## Technical Bulletin on Midship Mounted Fire Pump Shift Interlock

1202518

Jan 5, 2017

Rev. 1

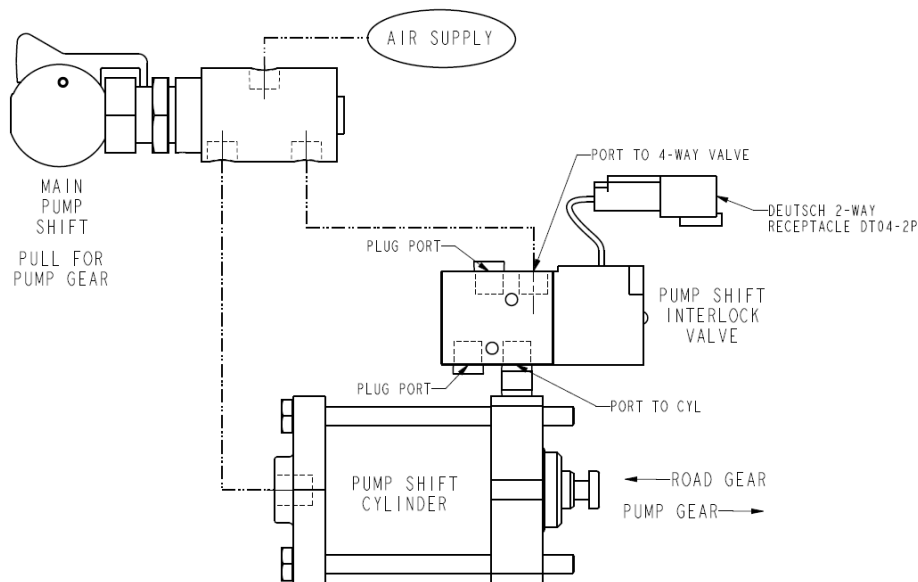
After Jan 1, 2016, all midship pump transmissions will include an air shift interlock valve assembly.

NFPA1901 (2016 Edition) 16.10.1.4 requires a shift interlock to prevent the pump drive from being shifted out of pump engaged+pumping mode of operation when the chassis transmission is in pump gear+

W.S. Darley & Co. has developed an interlock system for the pneumatic shift that prevents the pneumatic shift from actuating when signaled that the chassis transmission is in pump gear+. This will be standard equipment on W.S. Darley & Co.'s NFPA 1901 midship transmissions ordered after January 1, 2016.
